CITY OF NORTH RICHLAND HILLS

20-004 PUBLIC WORKS RESTROOM RENOVATION PROJECT
ADDENDUM NO. 2

NORTH RICHLAND HILLS SERVICE CENTER REMODEL
7200 A DICK FISHER DRIVE SOUTH
NORTH RICHLAND HILLS, TEXAS 76180

SHEET NUMBER
A101

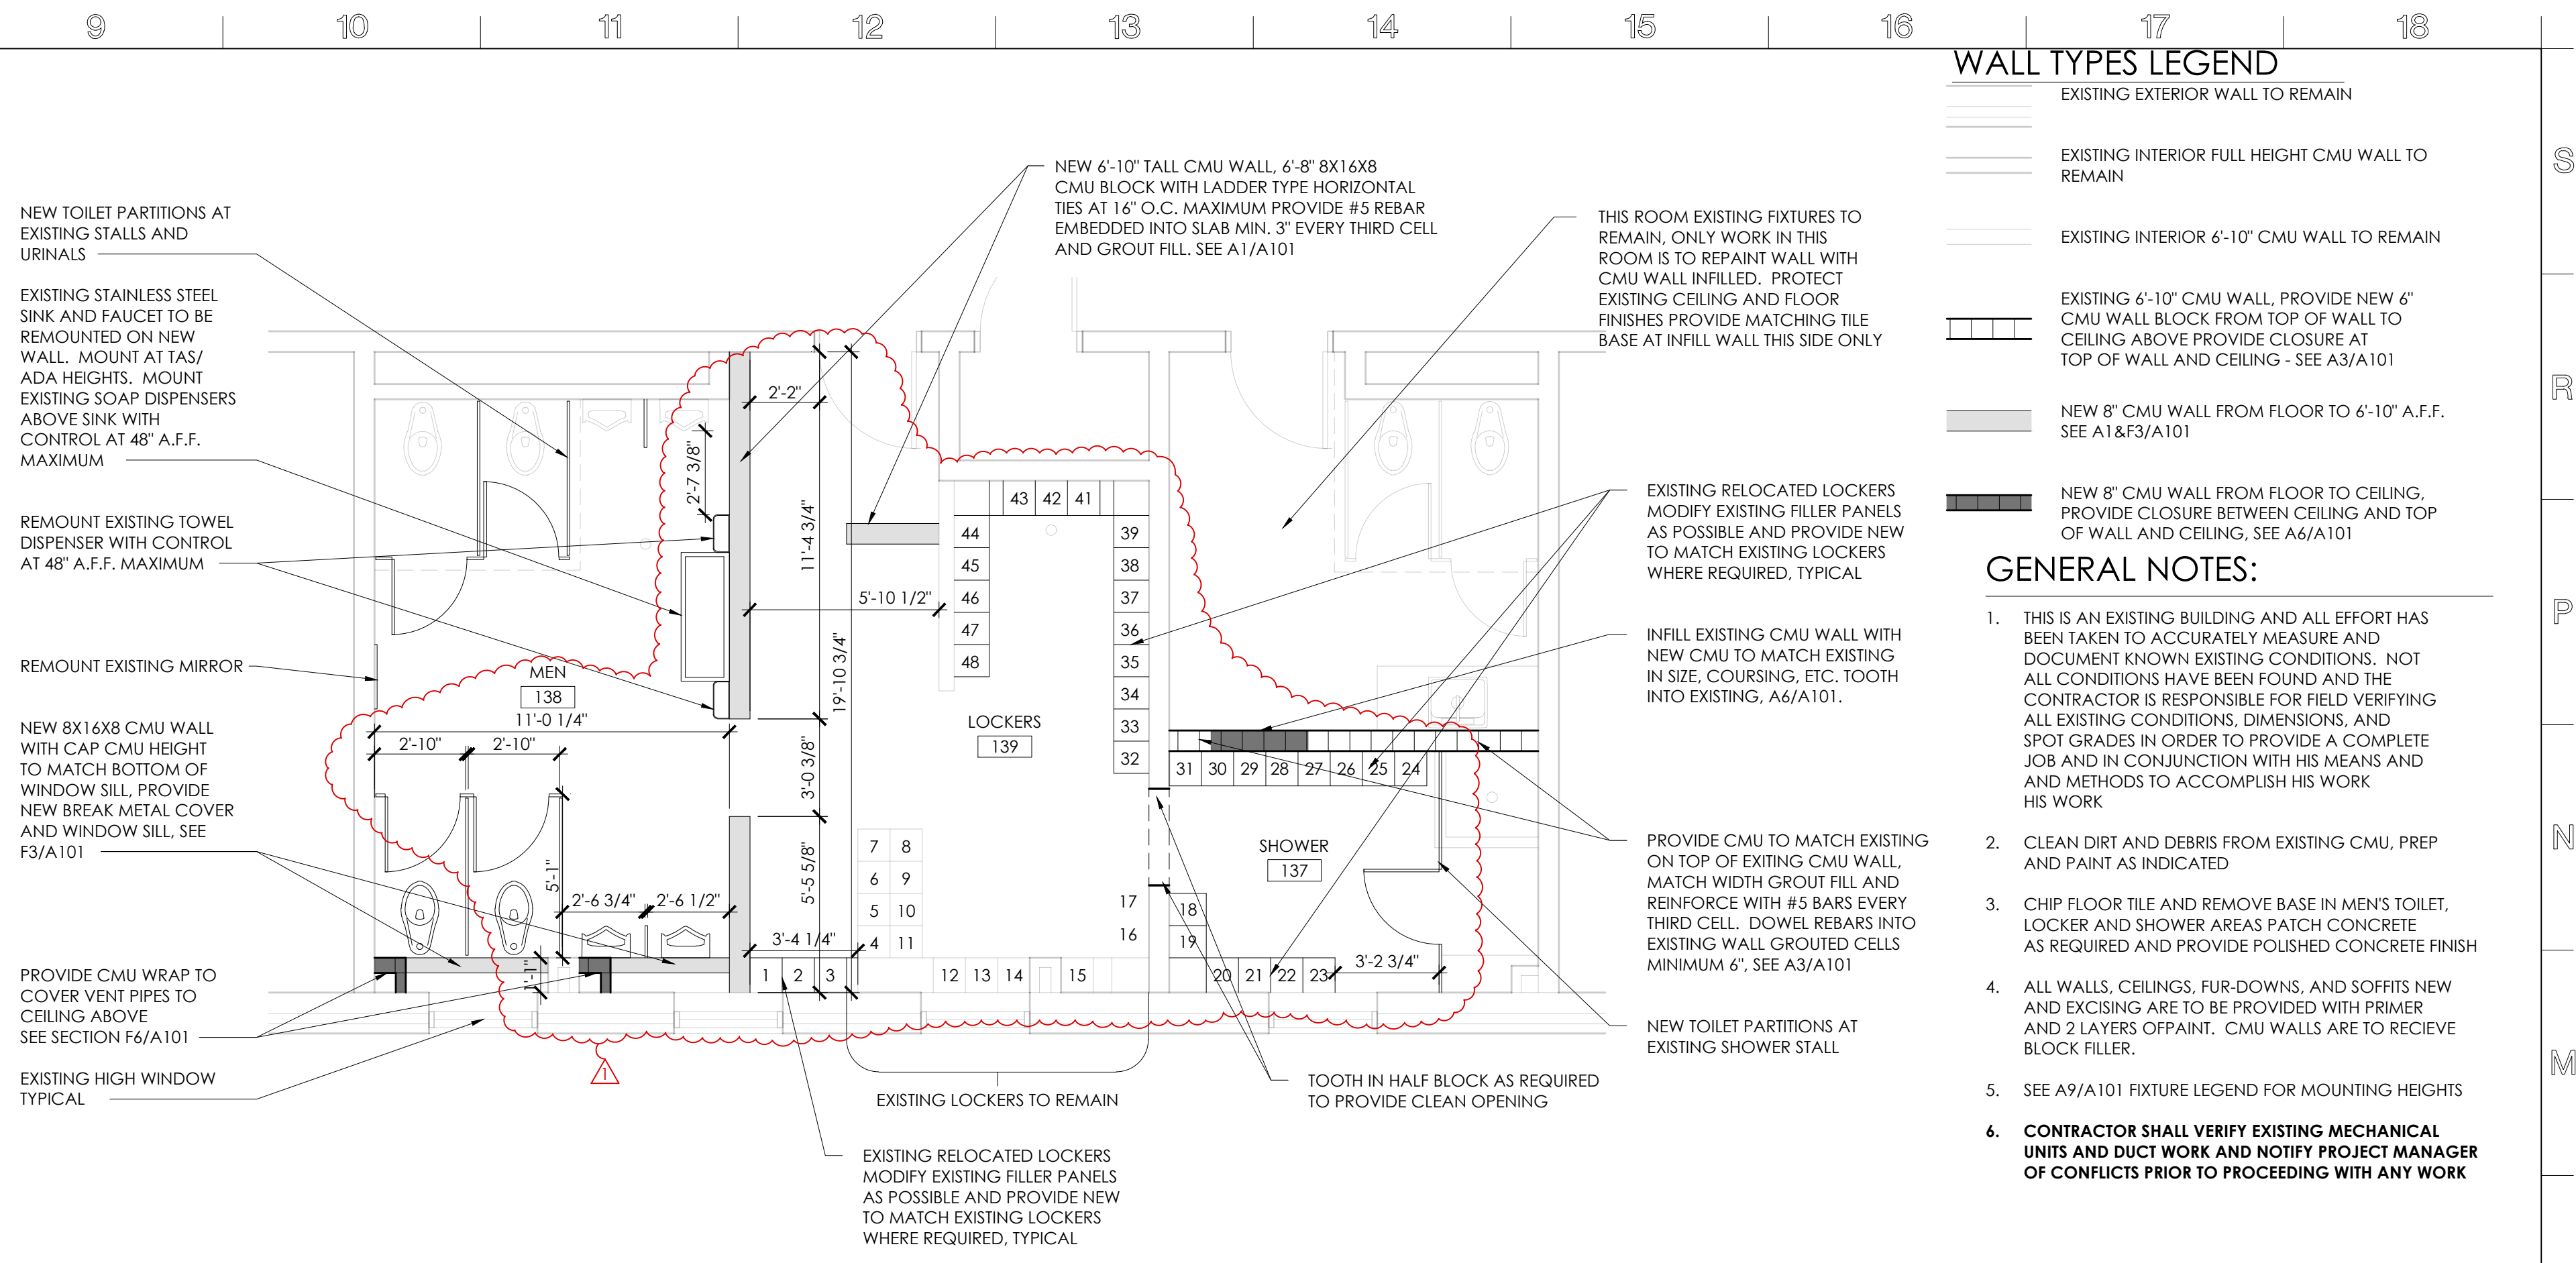
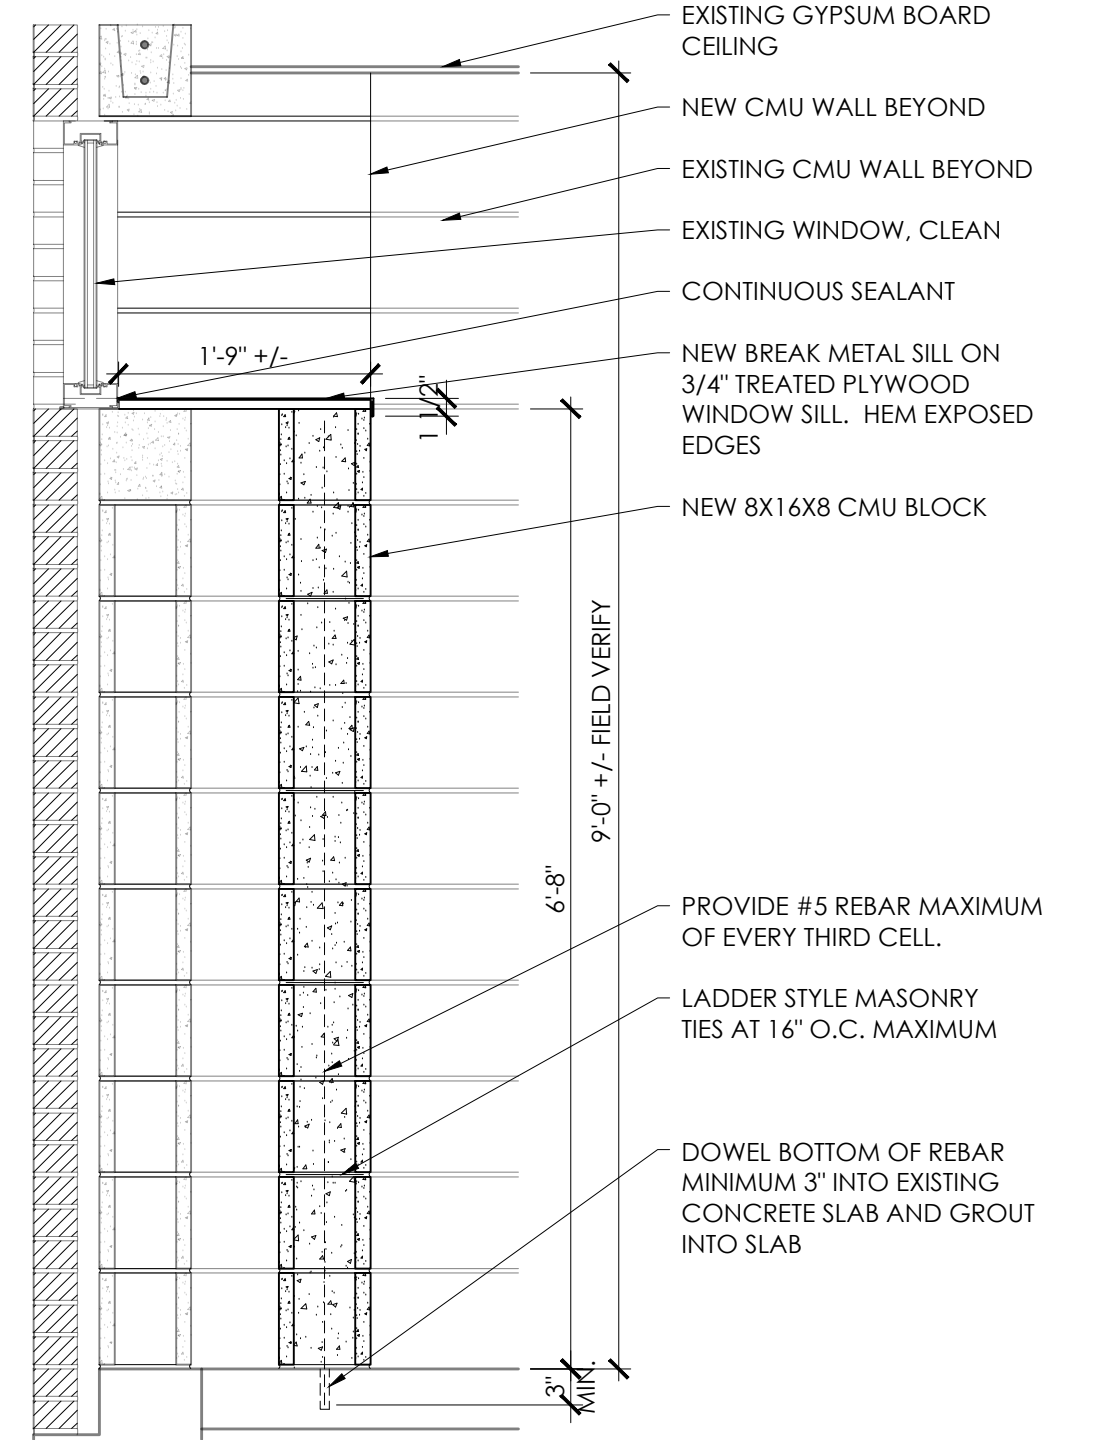
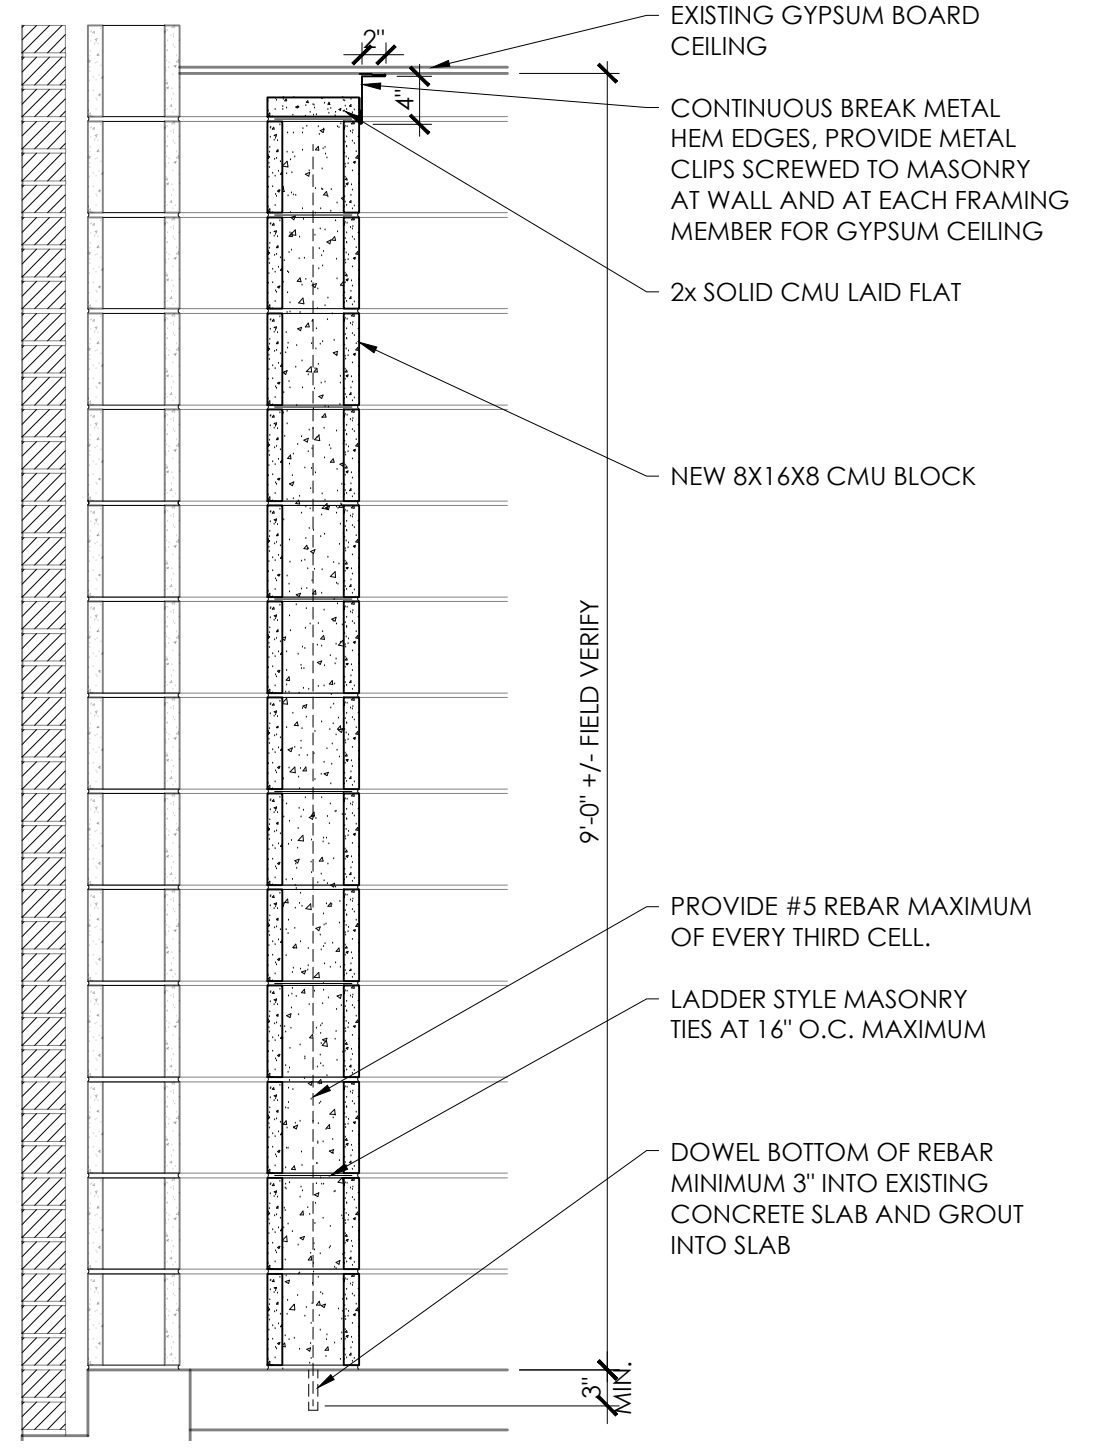
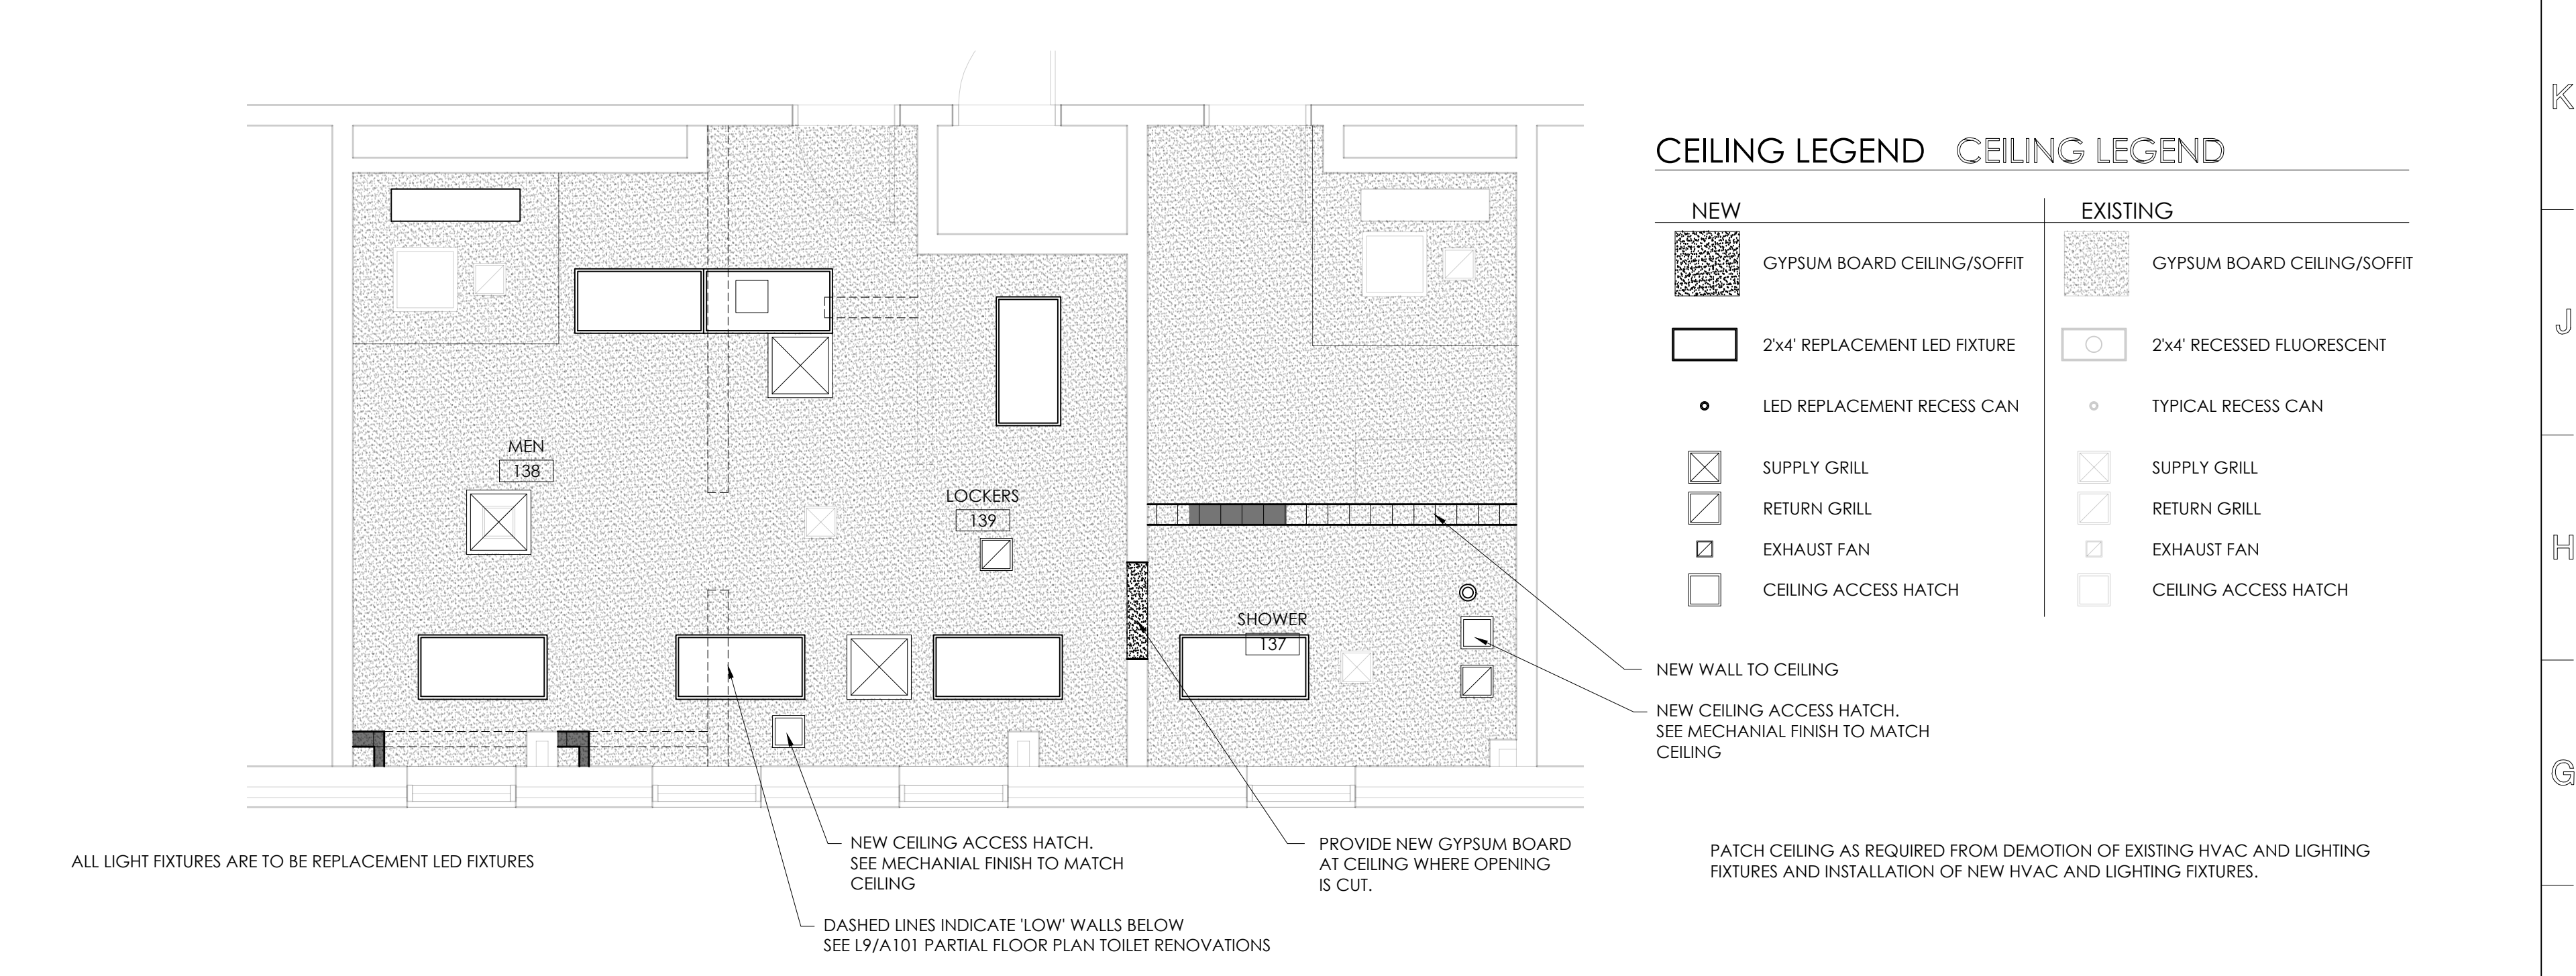
- 1) Specifications provided for the New Toilet Partitions, hardware and Toilet Stalls Accessories
- 2) On the Demolition plans, Sheet A101 has been replaced with attached drawing A101 REV1.
- 3) ADDENDUM NO. 1 is the pre-bid meeting minutes and sign-in sheet, and will not have a separate signature sheet.
